# Change Order #2

Locations of Change Order items for Bird Creek Interceptor Phase 4C

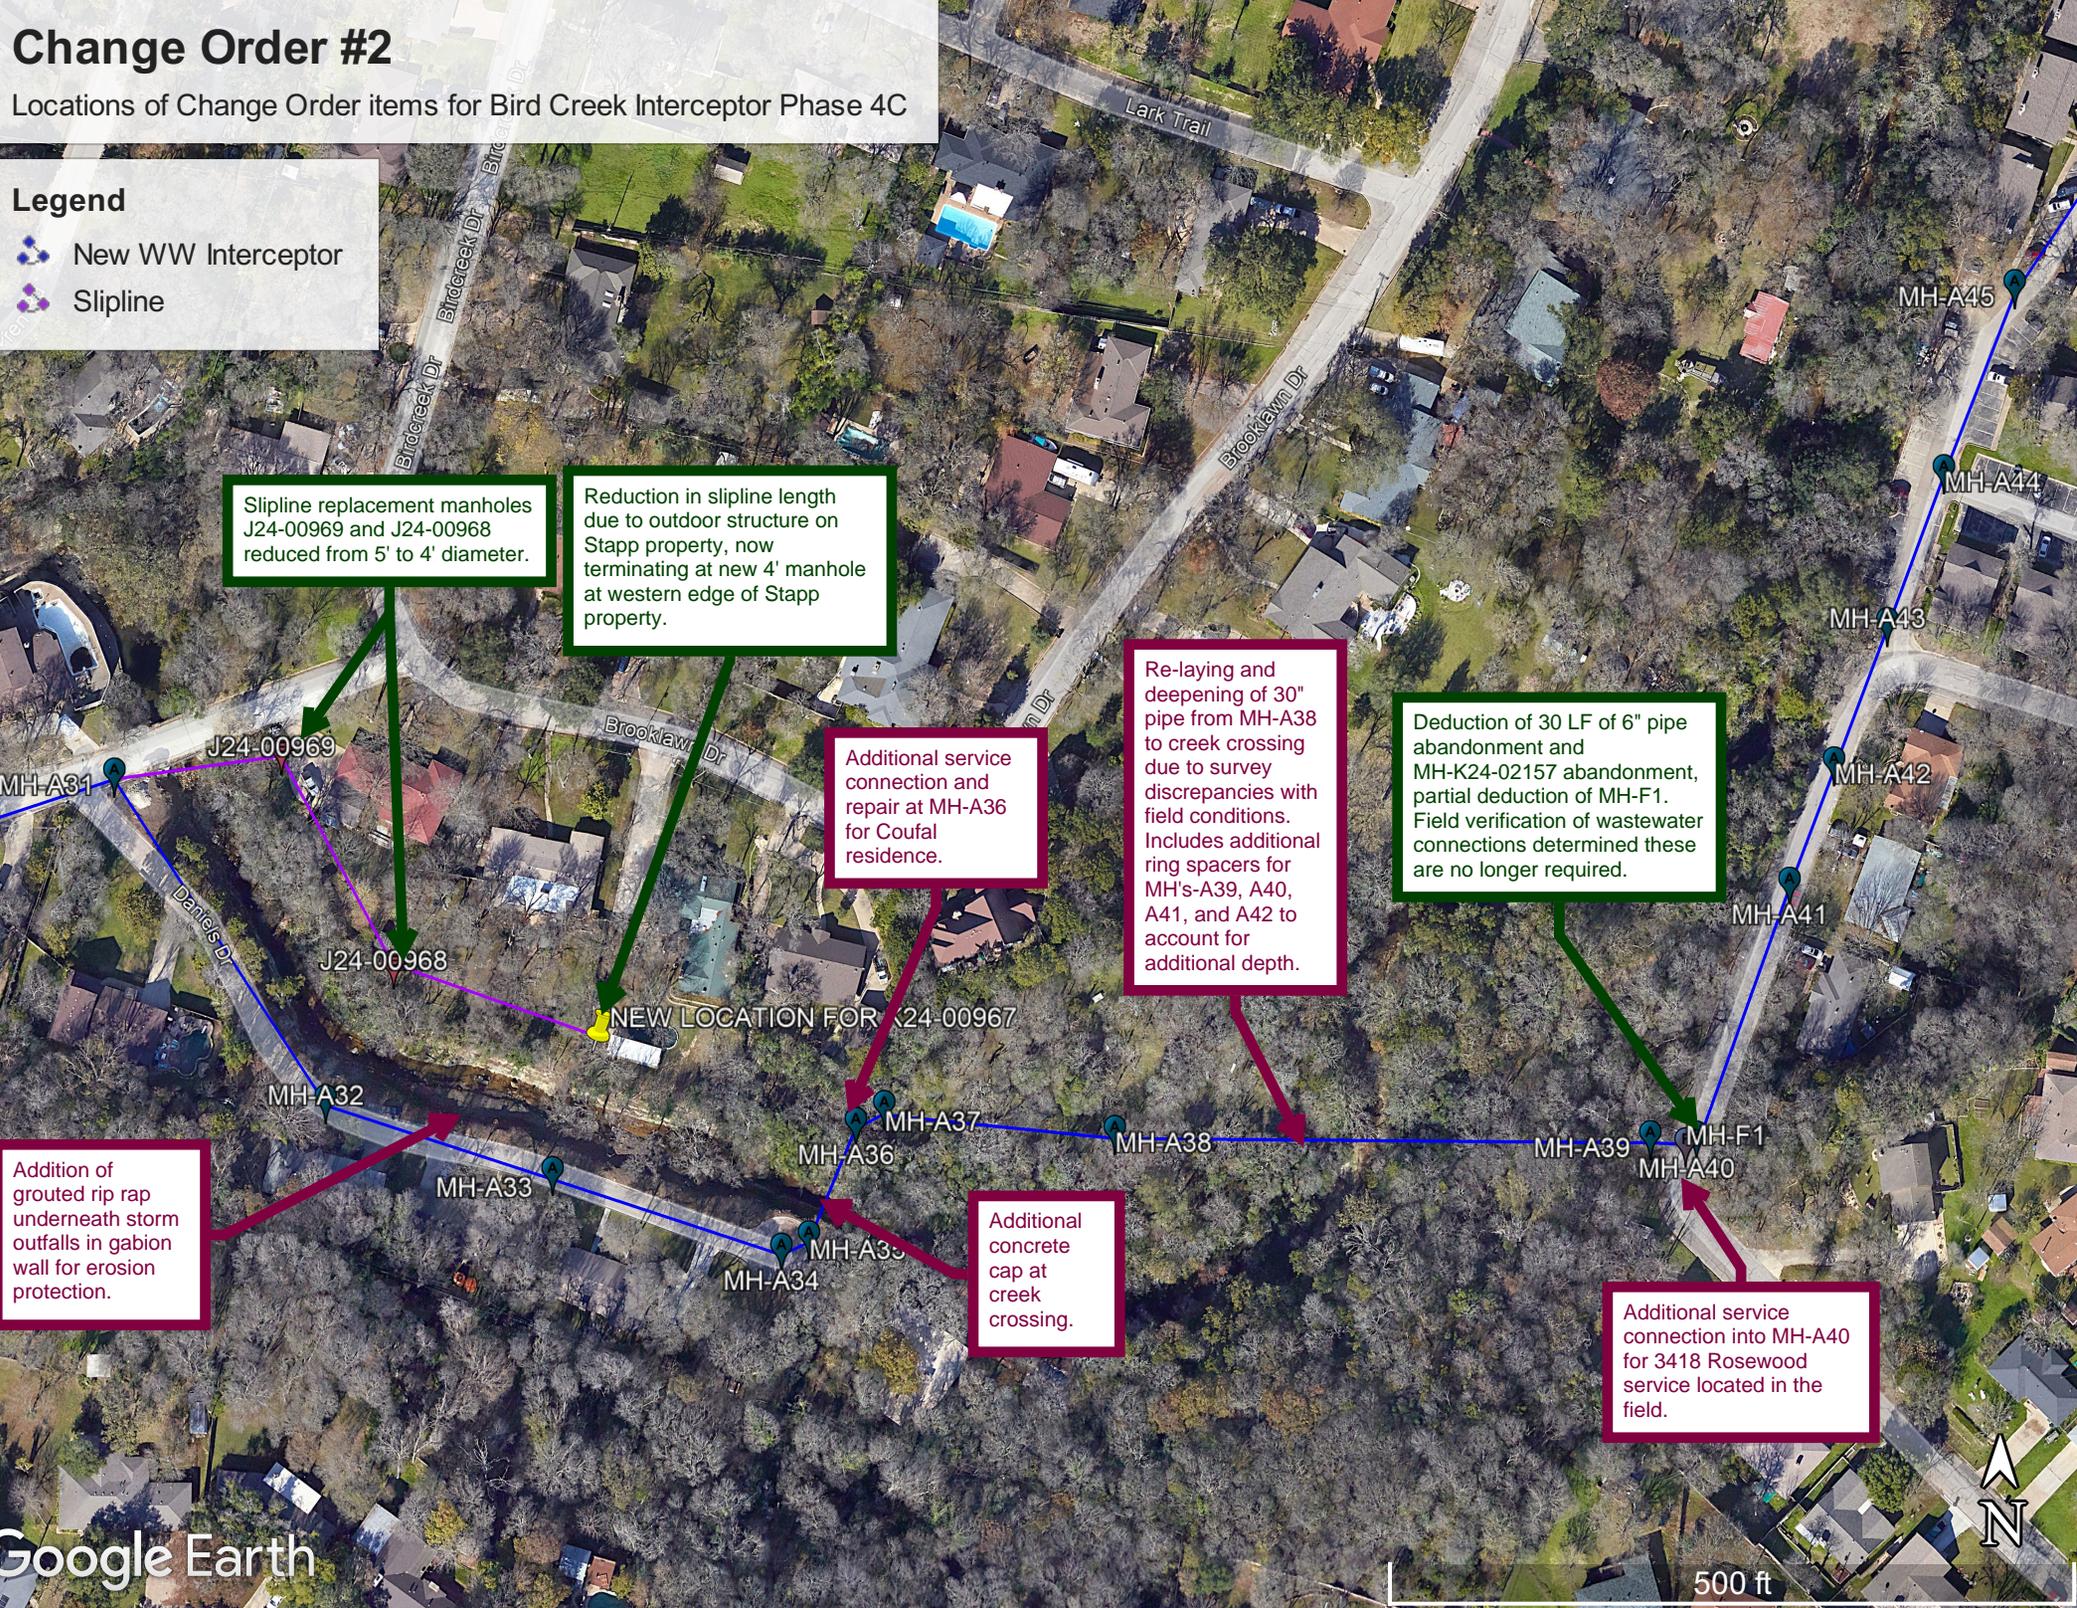
Slipline replacement manholes J24-00969 and J24-00968 reduced from 5' to 4' diameter.

Reduction in slipline length due to outdoor structure on Stapp property, now terminating at new 4' manhole at western edge of Stapp property.

Additional service connection and repair at MH-A36 for Coufal residence.

Re-laying and deepening of 30" pipe from MH-A38 to creek crossing due to survey discrepancies with field conditions. Includes additional ring spacers for MH's-A39, A40, A41, and A42 to account for additional depth.

Deduction of 30 LF of 6" pipe abandonment and MH-K24-02157 abandonment, partial deduction of MH-F1. Field verification of wastewater connections determined these are no longer required.

Addition of grouted rip rap underneath storm outfalls in gabion wall for erosion protection.

Additional concrete cap at creek crossing.

Additional service connection into MH-A40 for 3418 Rosewood service located in the field.
